SHOP DRAWING TRANSMITTAL

FIU PEDESTRIAN BRIDGE 434688-1-58-01
PT DECK, CANOPY AND TRUSS SHOP DRAWING
SUMMARY OF REVIEW COMMENTS BY CEG 6/26/2017 from FDOT D6

REFERENCE: UniversityCity Prosperity Project
Project ID BT-904
Submittal #000462-1.B, Post Tensioning – Deck, Canopy, Truss
(Revised)
FIGG Project No. 2262.06

Post Tensioning (Deck, Canopy & Truss)

SHEET: PT02

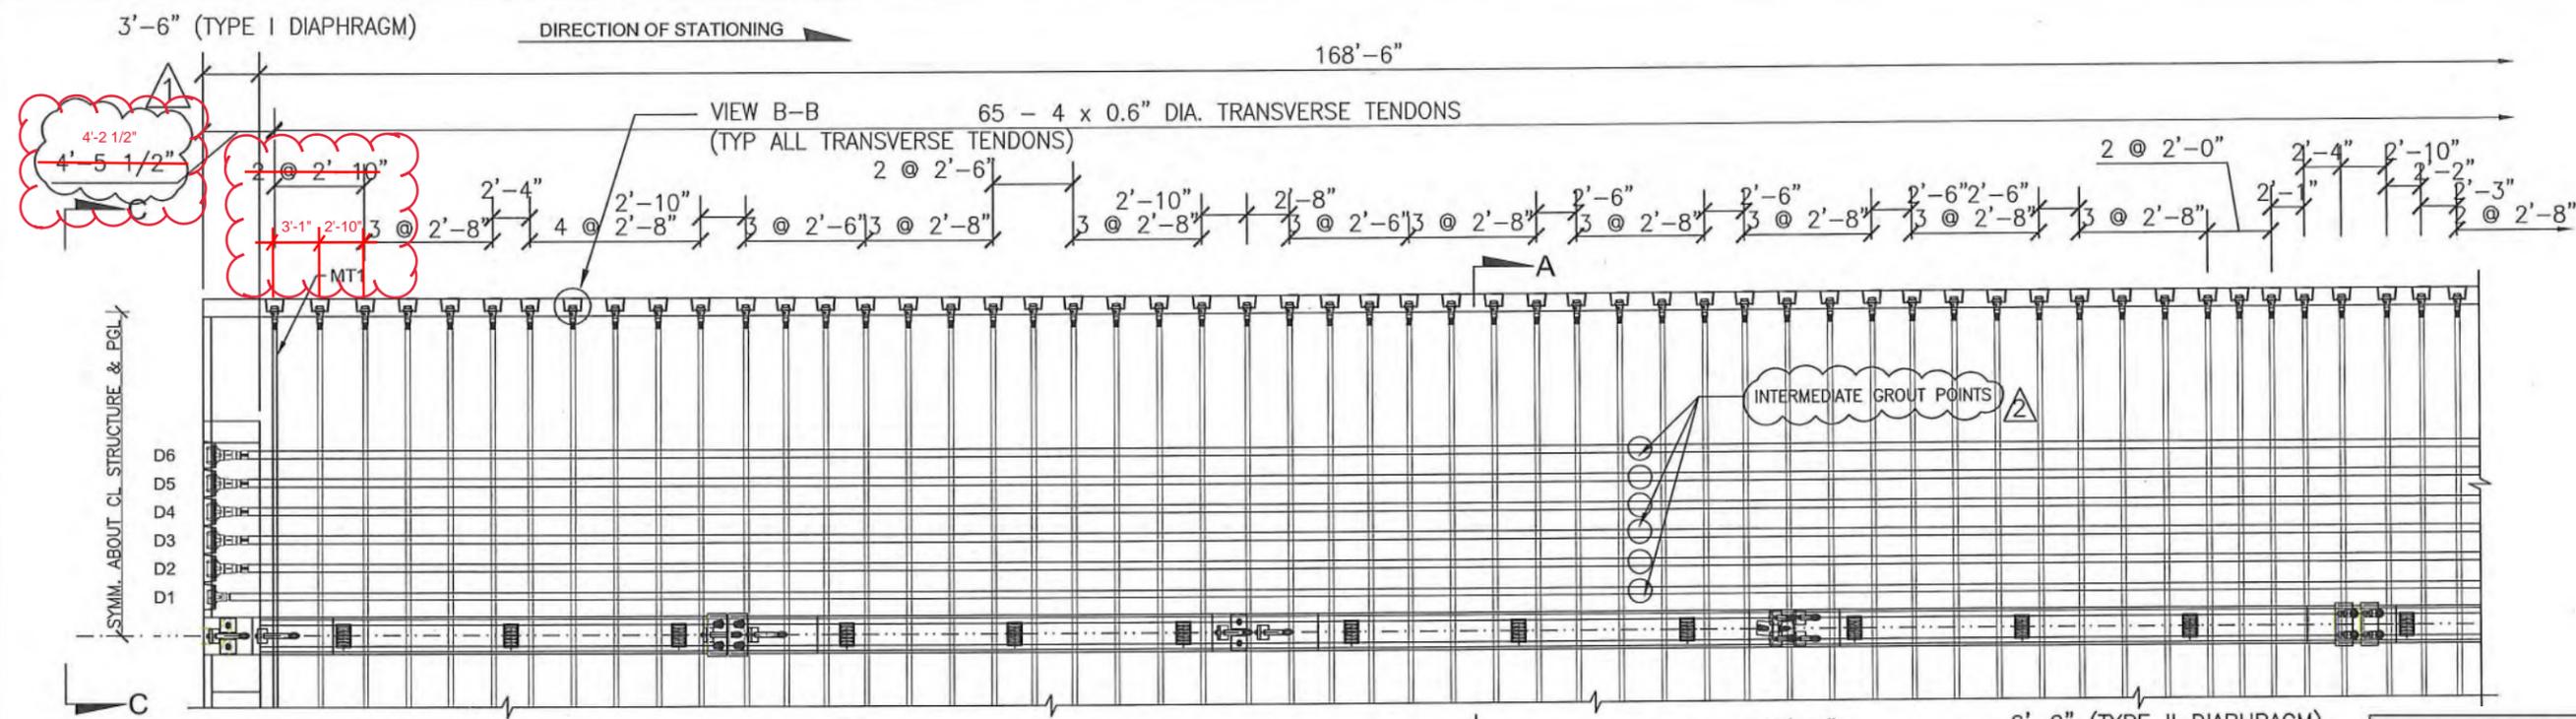
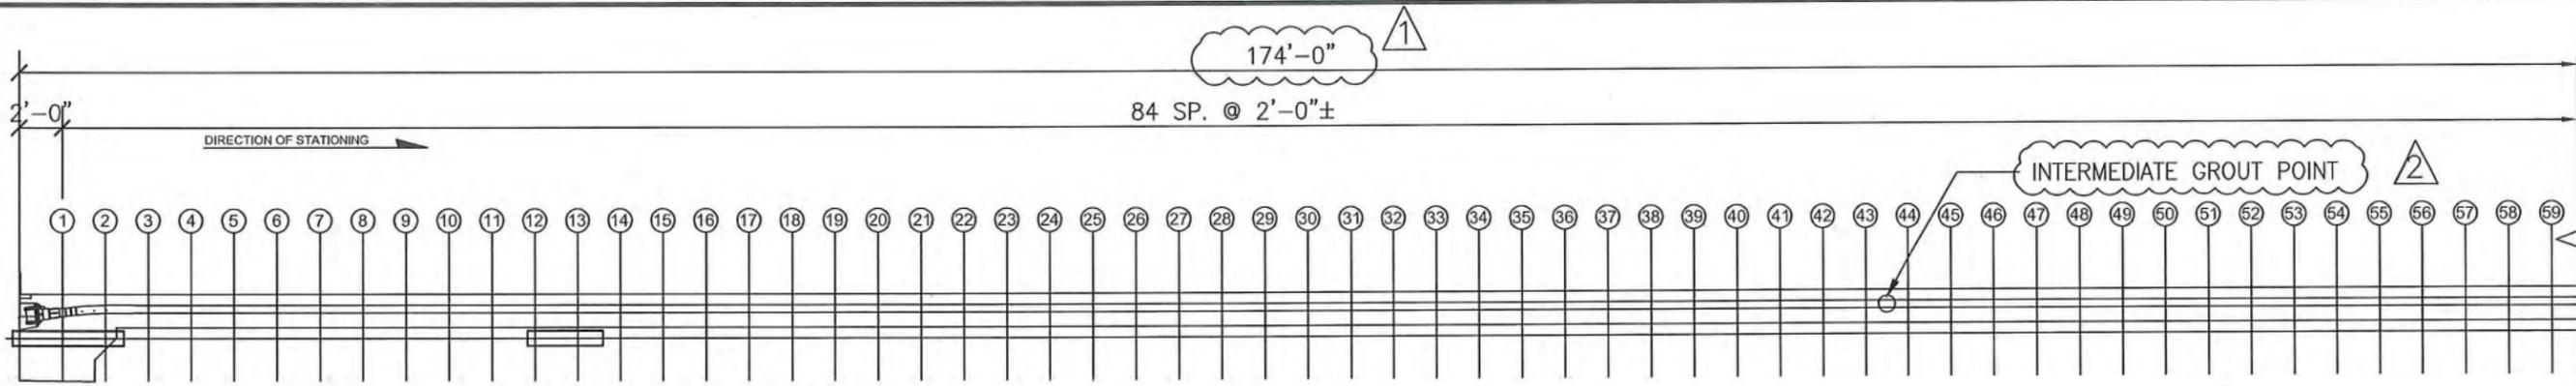
| <u>SHEET ID</u> | <u>COMMENT</u> |
|-----------------|--|
| PT02 | ELONGATION VALUES SHOWN ARE CALCULATED BY VSL AND DIFFER FROM PLAN SHEET B-69 |
| PT02 | 4'-0 3/8" DIM DIFFERS FROM 4'-0 1/2" SHOWN ON SHEET B-60 AND END OF MAIN SPAN. |

ELONGATION VALUES SHOWN ARE CALCULATED BY VSL AND DIFFER FROM PLAN SHEET B-69

4'-0 1/2" PER SHEET B-60

Add note referencing Sheets B-109 & B-110 for overall stressing sequence.

BLOCKOUT DETAIL B6 [3 TOTAL]
(BY OTHERS) SCALE: 1" = 1'-0"

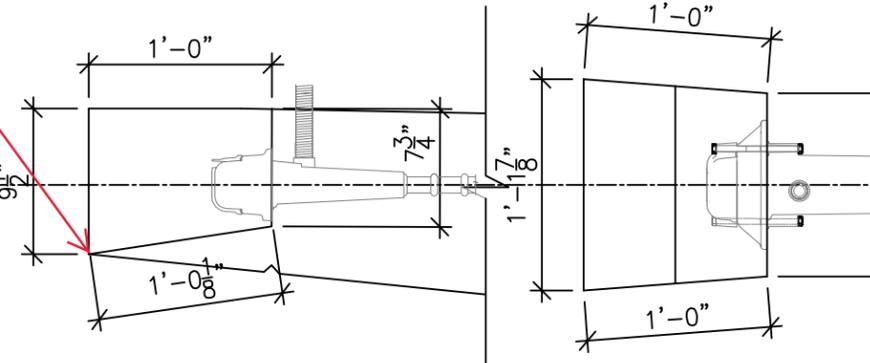
Modify blockout shape to prevent spalling at this corner during stressing of the tendon.

SCALE: VARIES
JOB NO: 420582
SHEET: PT02.6

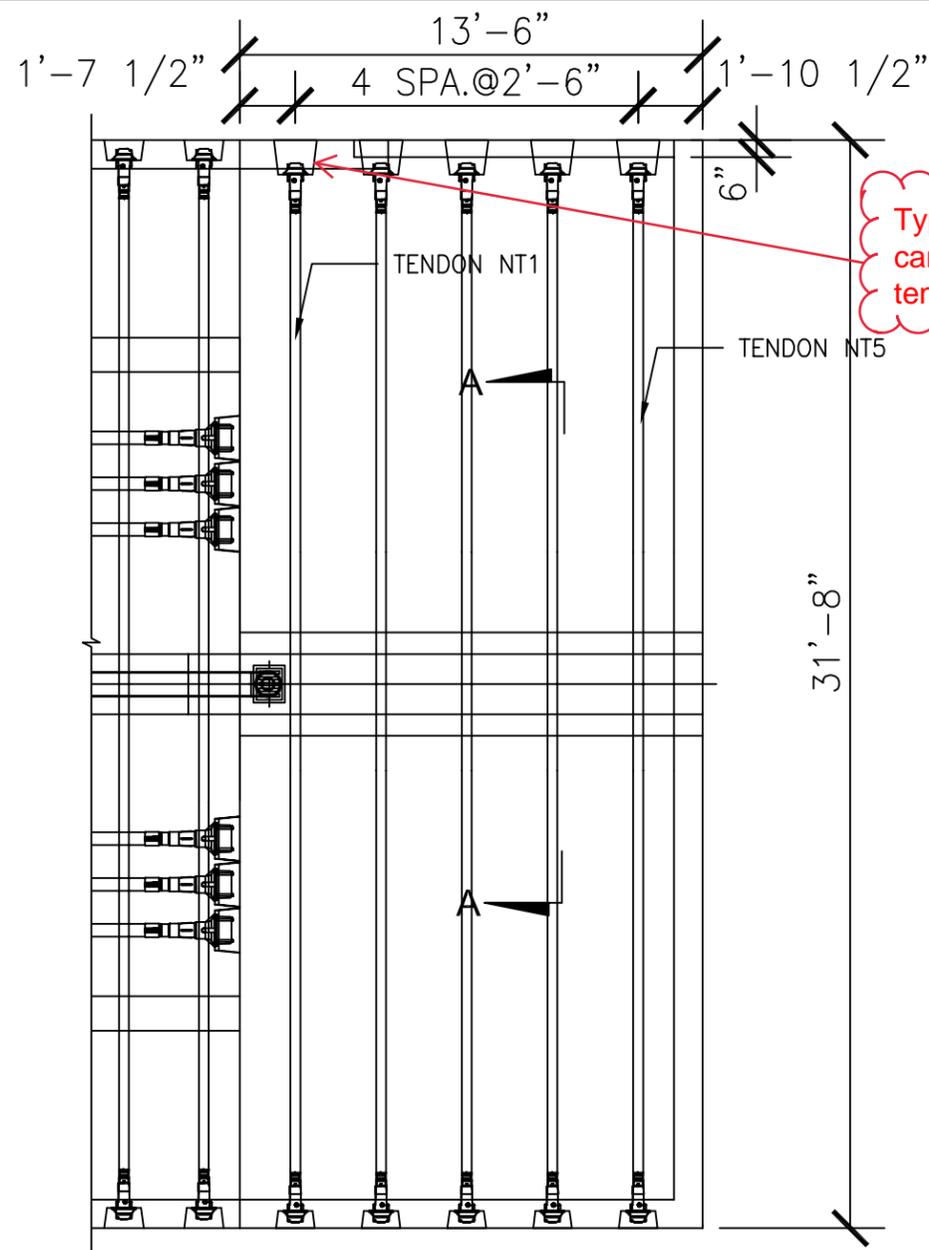
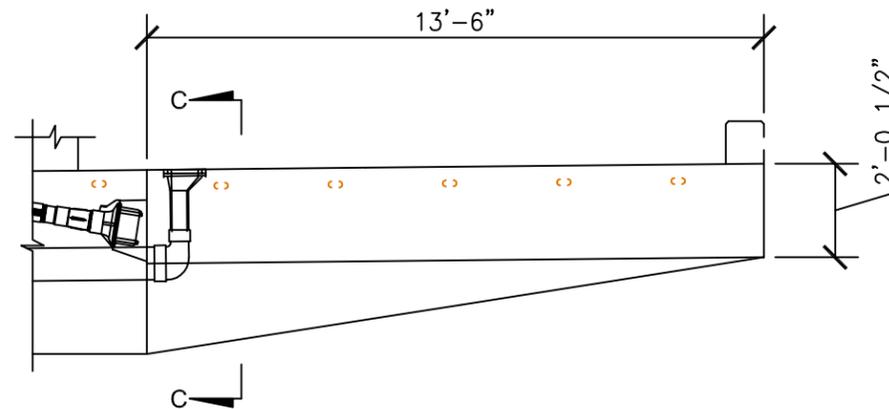
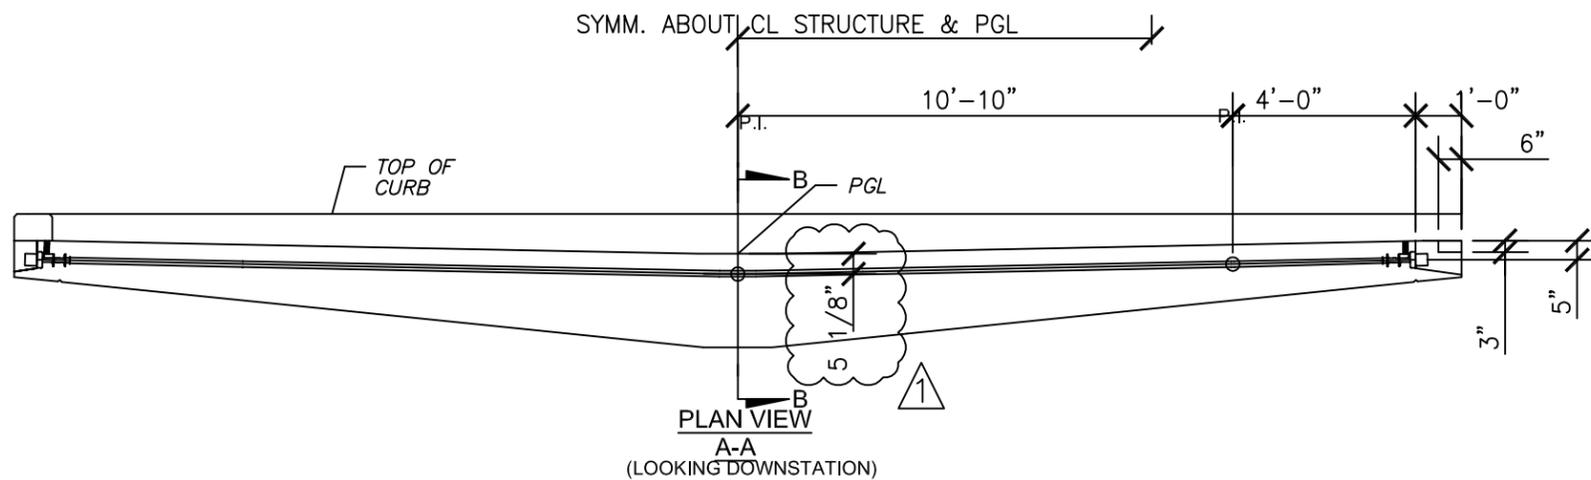
Typical breakout can be used for tendon NT1.

Add breakout details for transverse tendons NT1-NT5.

SCALE: VARIES
 JOB NO: 420582
 SHEET: PT03

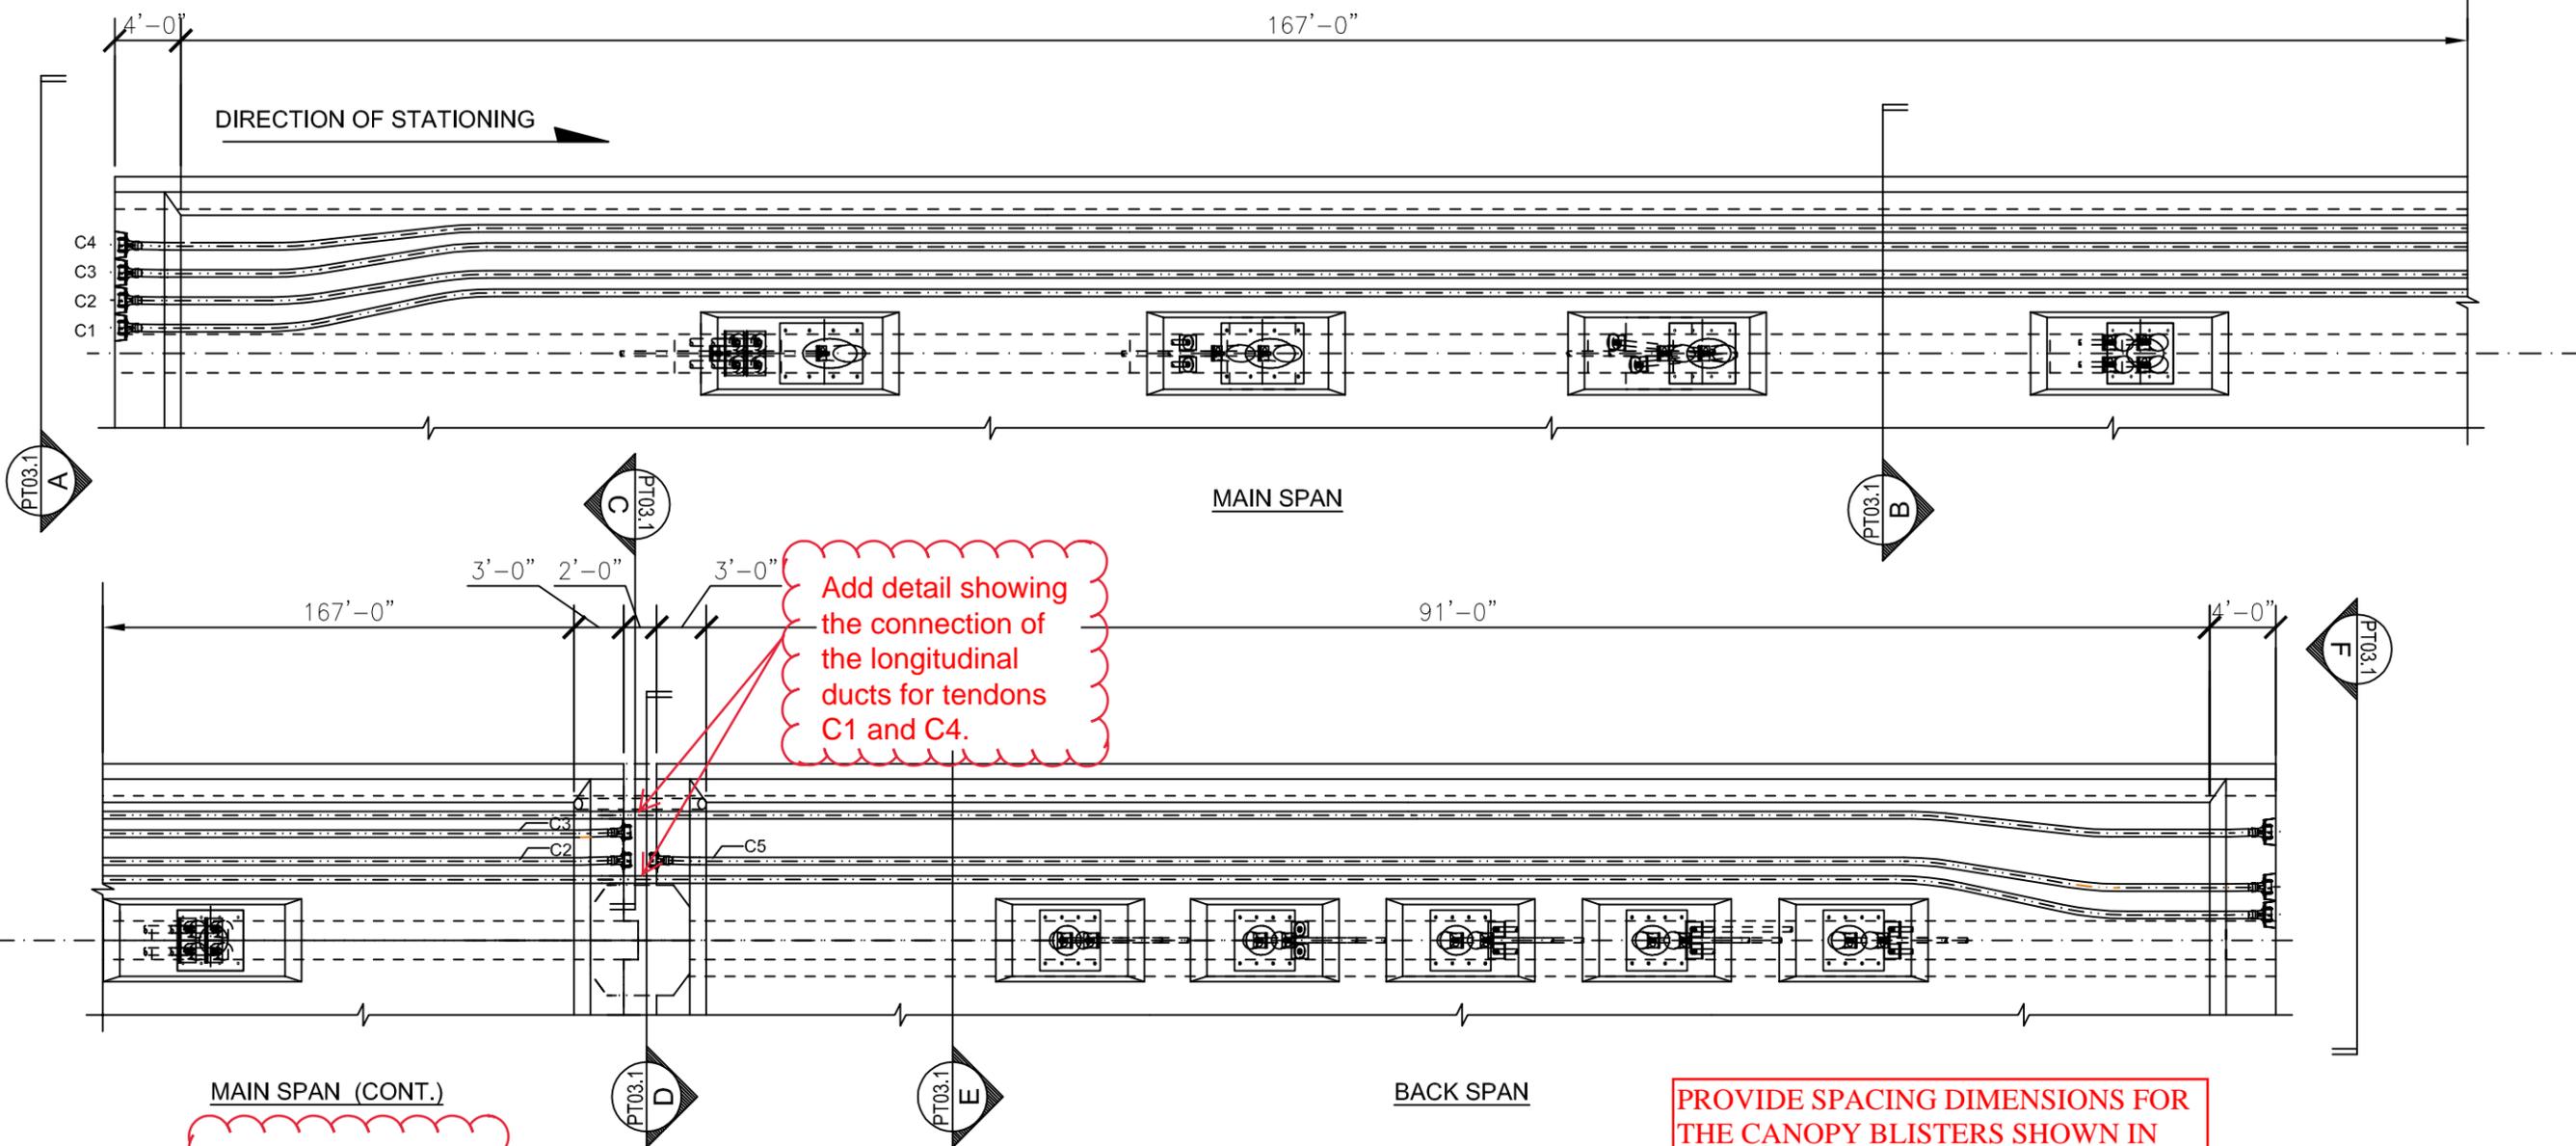
| <u>SHEET ID</u> | <u>COMMENT</u> |
|-----------------|--|
| PT03 | ELONGATION VALUES SHOWN ARE CALCULATED BY VSL AND DIFFER FROM PLAN SHEET B-69 |
| PT03 | PROVIDE SPACING DIMENSIONS FOR THE CANOPY BLISTERS SHOWN IN PLAN VIEW |

Add note referencing Sheets B-109 & B-110 for overall stressing sequence.

Add detail showing the connection of the longitudinal ducts for tendons C1 and C4.

PROVIDE SPACING DIMENSIONS FOR THE CANOPY BLISTERS SHOWN IN PLAN VIEW

ELONGATION VALUES SHOWN ARE CALCULATED BY VSL AND DIFFER FROM PLAN SHEET B-69

SCALE: VARIES
 JOB NO: 420582
 SHEET: PT03.4

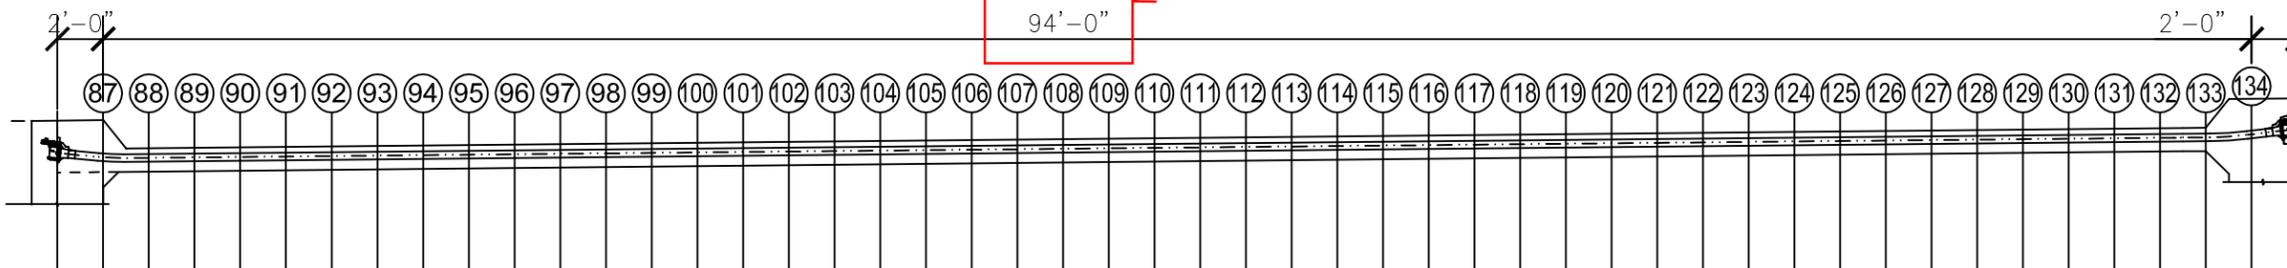
| <u>SHEET ID</u> | <u>COMMENT</u> |
|-----------------|--|
| PT03.4 | SHOW 2'-0" SPACING IN 94FT BACK SPAN REGION. |
